RIX'S CREEK NORTH MINE MODIFICATION 9

LANDFORM AMENDMENT EXPLORATION AND BLASTING FREQUENCY RESPONSE TO SUBMISSIONS

BLOOMFIELD COLLIERIES PTY LIMITED

RESPONSE TO SUBMISSIONS

FIGURE 1

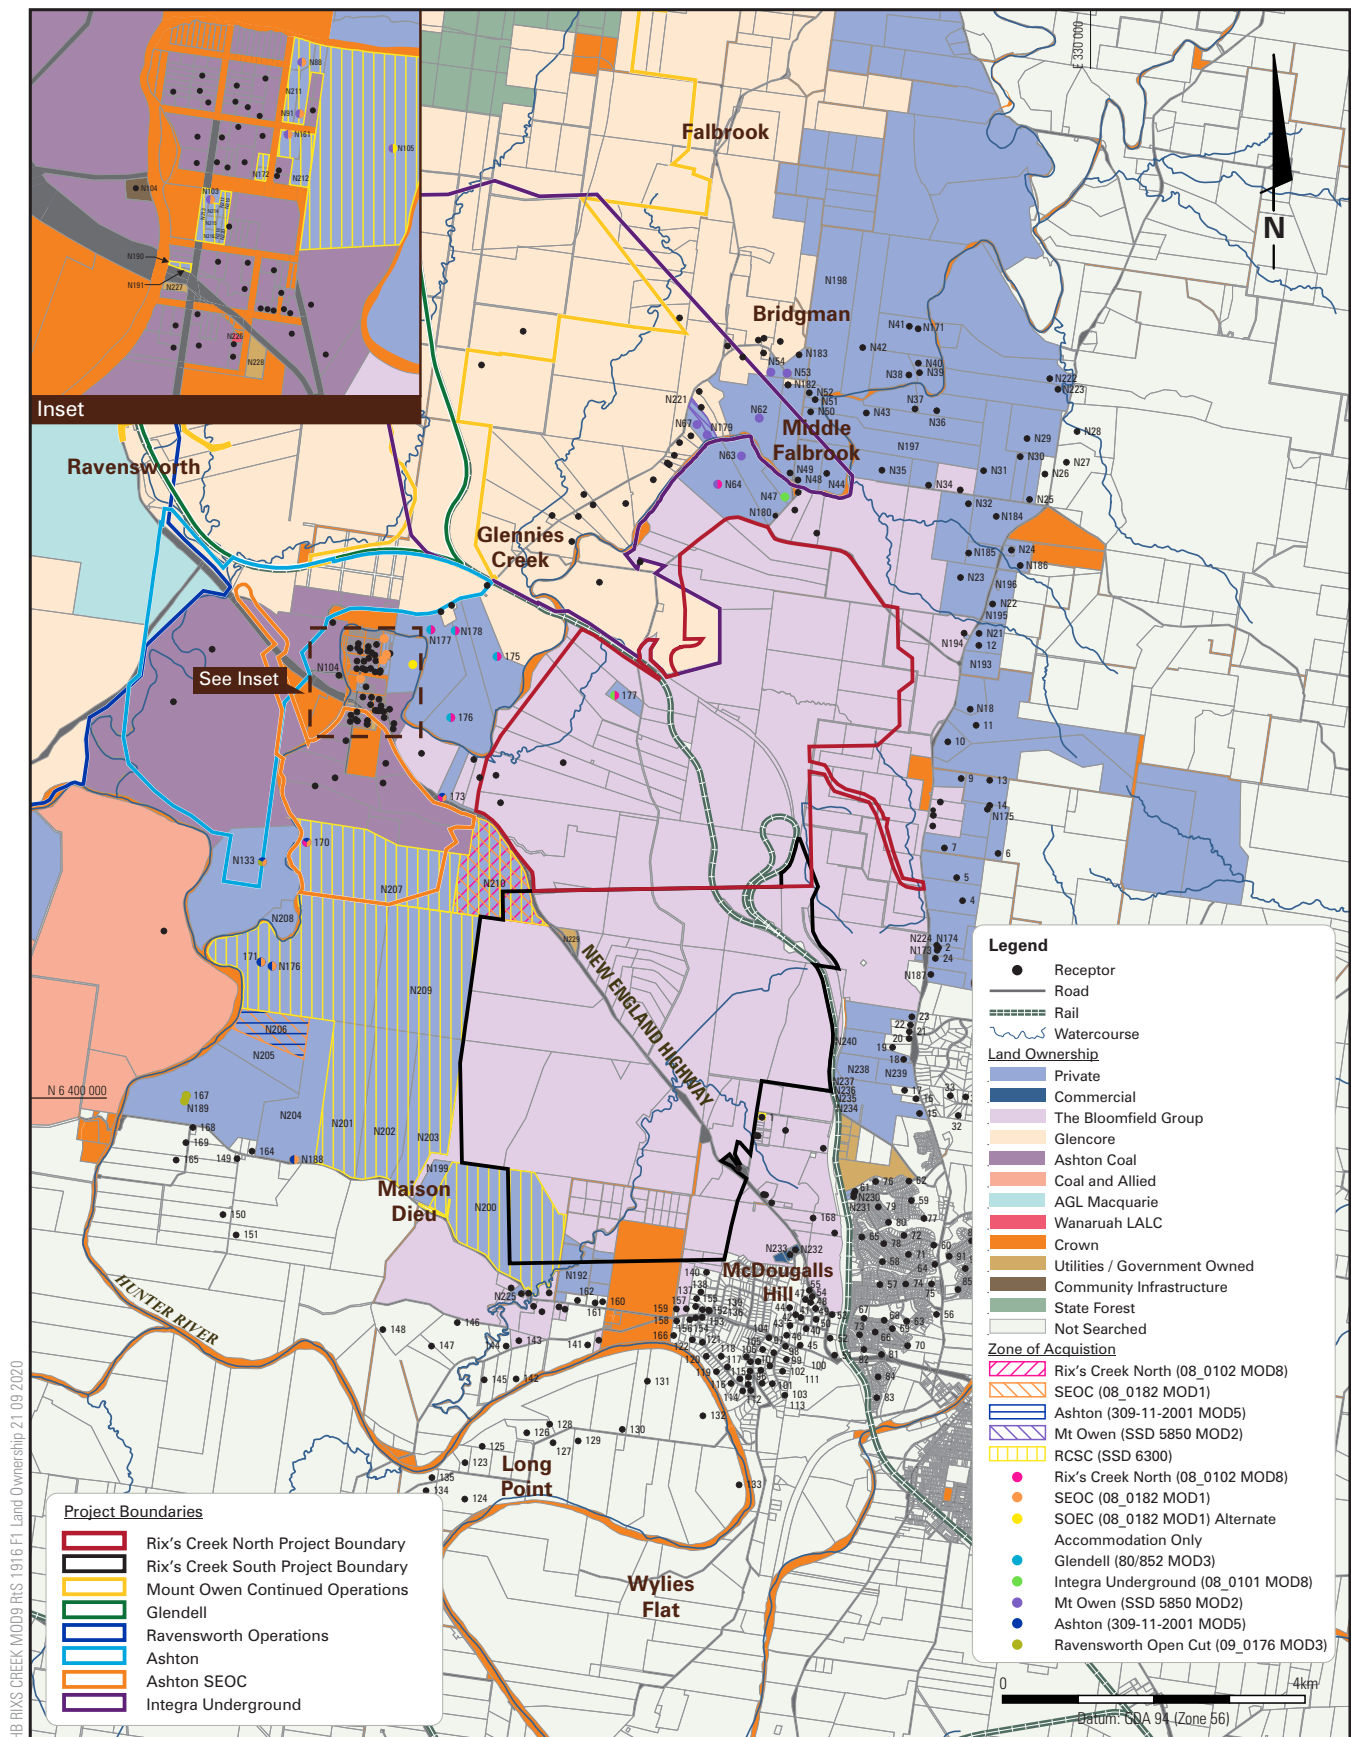
An objection was received by one adjacent property owner based on three main points:

- The height of the overburden emplacement area and its potential to increase dust;
- The impacts of blasting; and
- Further exploration potentially causing the mine to further encroach on lifestyle.

This property contains residences N11 and N18 as shown on **Figure 1** and is located generally east of RCN. No exceedances of noise, blast or air quality criteria is predicted by the relevant SEE specialist assessments. Further, a ridge (which runs northwest to southeast between these two residences and the overburden emplacement area proposed to be modified) obscures any views.

N11 and N18 are not included in an existing zone with rights to acquisition or mitigation for any mining operation in accordance with the VLAMP.

Figure 1: Annual average PM₁₀ concentrations

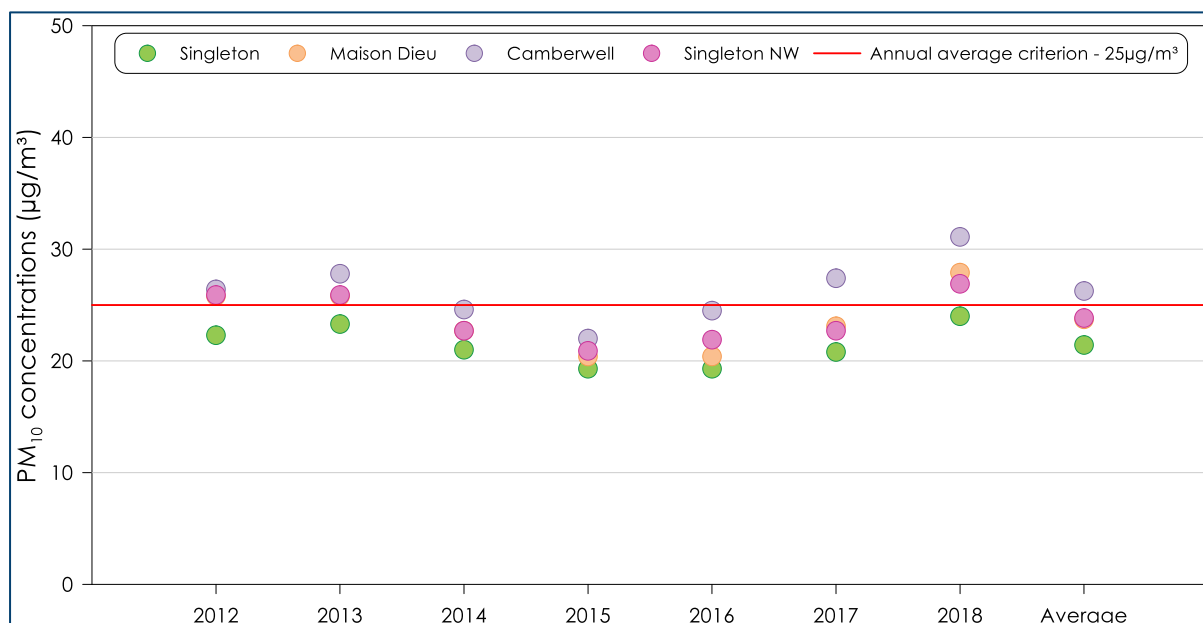
In regard to the EPA comment that the 2012 data are inappropriate because they are 8 years old, and unlikely to account for changed activities around the mine that have occurred since 2012, **Figure 1** plots the annual average PM₁₀ concentrations from nearby ambient monitoring stations in the Upper Hunter Air Quality Monitoring Network (UHAQMN) taken from Table 4-3 of the AQIA. The data show that in 2012, the measurements at every monitor are higher than the average dust level at that monitor from 2012 to 2018. This indicates that the 2012 data will overestimate the average dust levels, and that the assessment overall is conservative. This suggests the more contemporary data do not indicate any significant change associated with activities around the mine since 2012, other than the normal inter-annual variability. However, any changes to the dust in the ambient air due to changed activities at the other mining operations are directly reflected in the actual modelling of these operations and shown in the predicted cumulative impacts. As the actual background data are higher than average, and as we have explicitly added the modelling of existing and future changes in dust from the other mines since 2012, there will be further conservatism in the assessment.
